# 11 Gibbons Street Redfern

SDRP Design Review Process Summary

**Preferred Concept**

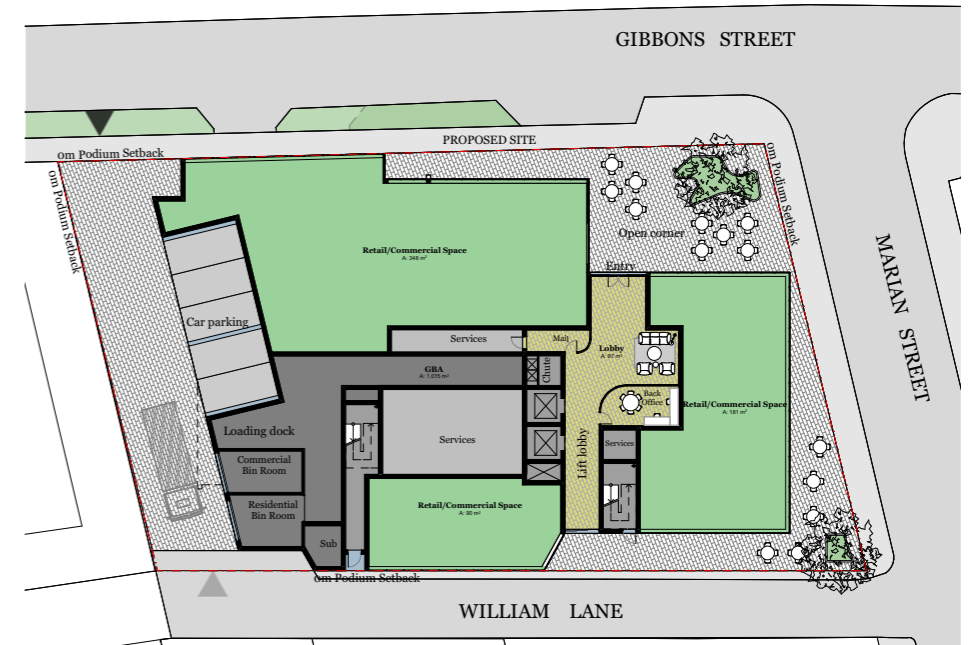
The preferred concept project presented to the first SDRP meeting in May 2018 proposed an 18 storey building comprising ground floor retail and 153 1 and 2 bed units.

- Retail and commercial fronting 3 streets – response to activation request in anticipation for laneway extension
- Open corner to decelerate wind around corner. A relief along the street front to form an opportunity for a forecourt that addresses the main entrance to the building.
- The concept of providing a one storey podium was presented in this session.
- The arrangement of the units were orientated due west to maximise solar access
- Communal open space was located at the rear of the site facing William Lane, protected from road noise. The principal COS area was located on the roof protected from wind between units
- Setback from southern boundary – to break up length of the façade and provide breathing space between buildings.
- Options of minimal and no on site parking explored.
- Vehicle access onto Gibbons Street for on site waste collection.

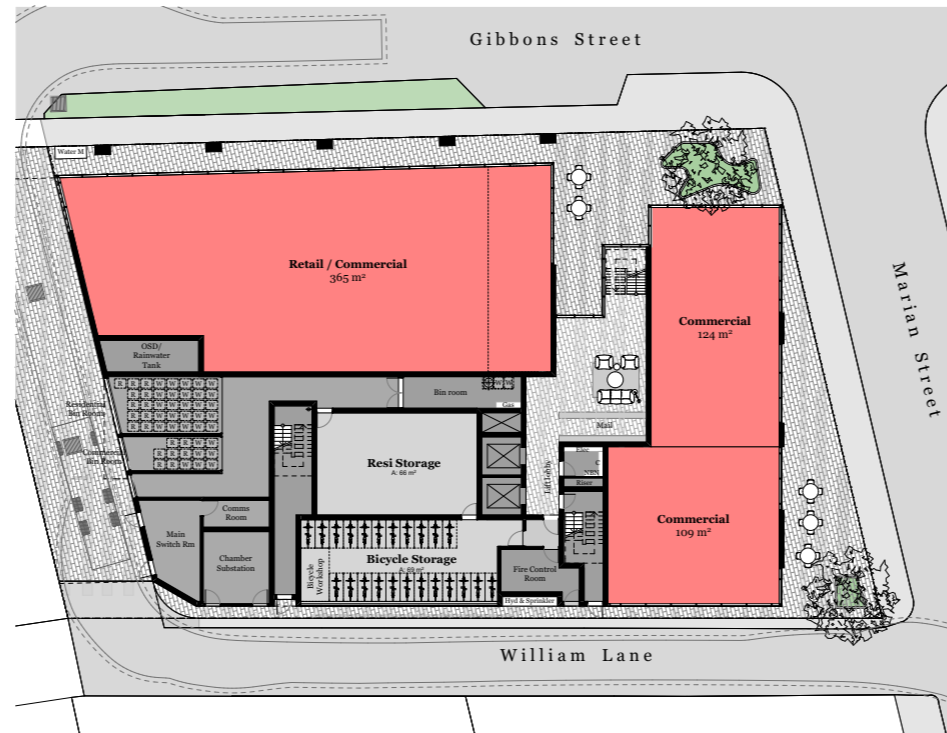
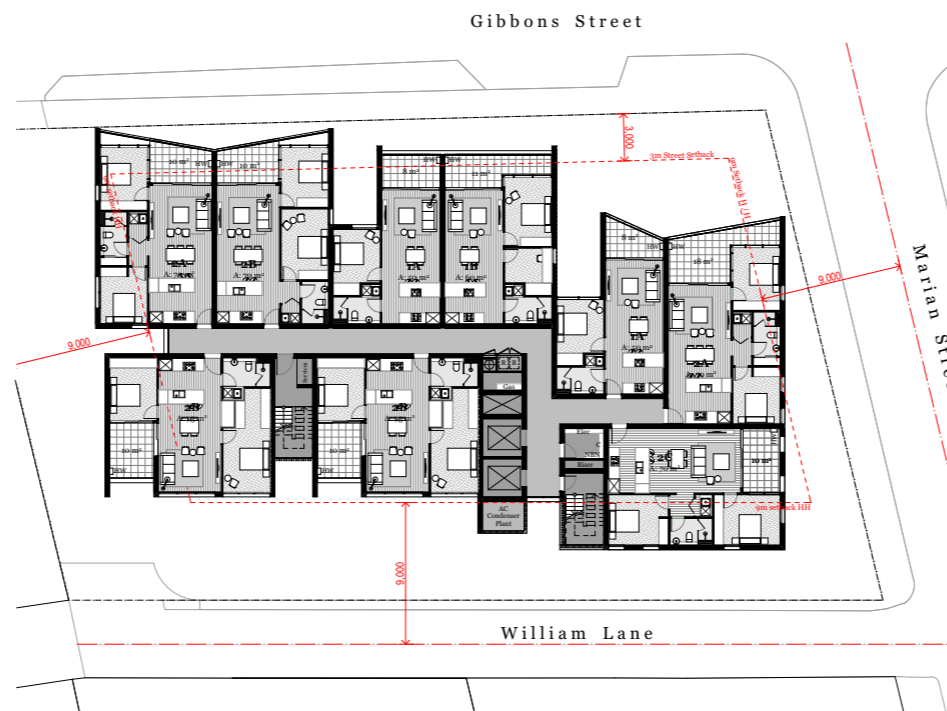
- Further development of floor plates and internal planning. This resulted in a total of 155 units with 16 x studios, 49 x 1 beds and 90 x 2 beds, showing a greater mix of unit types.

- Further development of the overall facade and massing articulation driven by amenity to dwellings.
- No parking provisions in the development.
- 3-4 storey podium massing. Key environmental constraints and contextual considerations were taken on board to drive the podium massing response.

- Communal open space located to the NW corner as per recommendations for better solar amenity. The location of COS seeks to add visual connection to street.

- Level 17 COS located in between tower forms to mitigate wind constraints.
- Locations of COS at multiple levels and other uses of the building seeks to create a composition of different uses that are reflected on the Gibbons facade.

- Residents common room coupled with the COS as per recommendations.
- Durable materials were presented for the external finishes including materials with a long life cycle and low maintenance.

- Engagement of Aboriginal Artist Joe Hurst (Boomali) workshops undertaken to discuss preliminary artworks and potential locations to incorporate works.

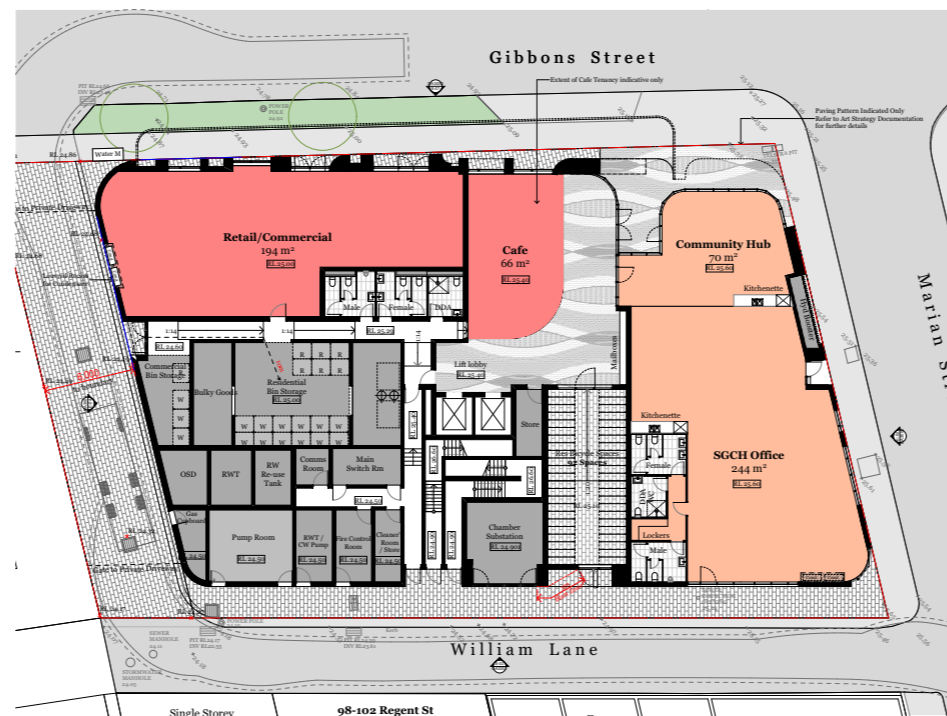
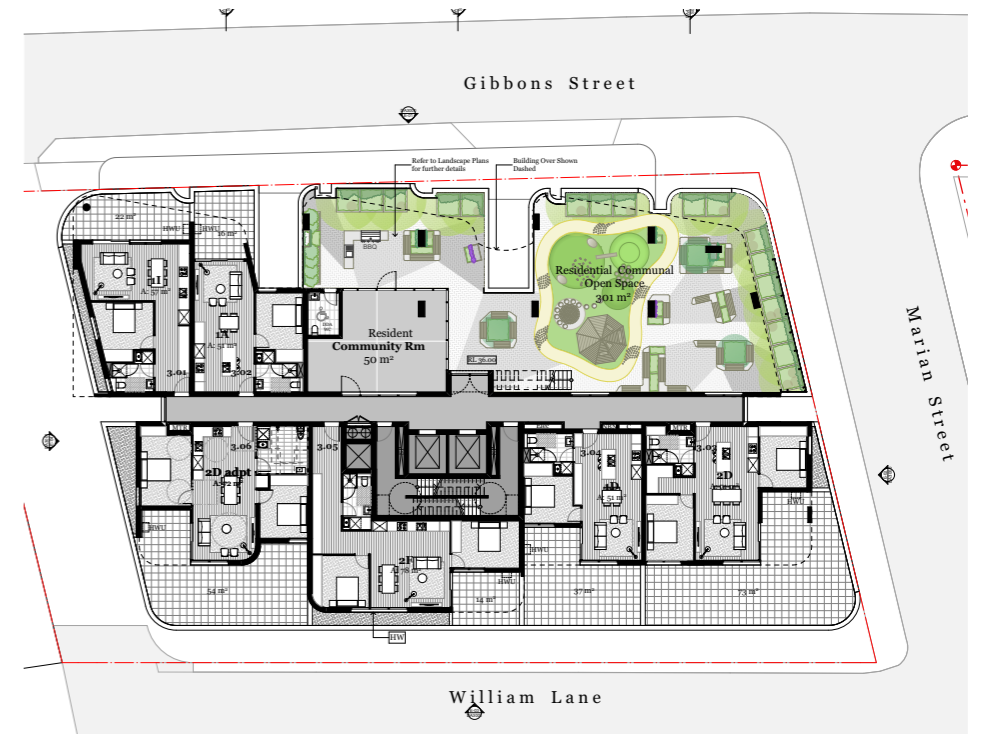
- 162 units comprising of 15 x studios, 47 x 1 beds, 96 x 2 beds and 2 x 3 beds. This also includes the provision of 2 dual key apartments to cater for intergenerational housing.

- Typical plate and internal planning developed. The development of the plans are driven by amenity to the units and also environmental measures raised by specialist consultants.

- Through consultation with the project wind specialist, the tower and podium massing forms curved corners to reduce wind impacts.

- Street awning provided to Gibbons Street to mitigate any downwash of wind.

- Generous COS is provided on level 3 exceeding the minimum requirements under the ADG.

- Resident's common room located adjacent to the COS for strong visual connection.

- Play area incorporated in level 3 COS to provide multiple uses for families

- Double height community hub provides a statement corner element.
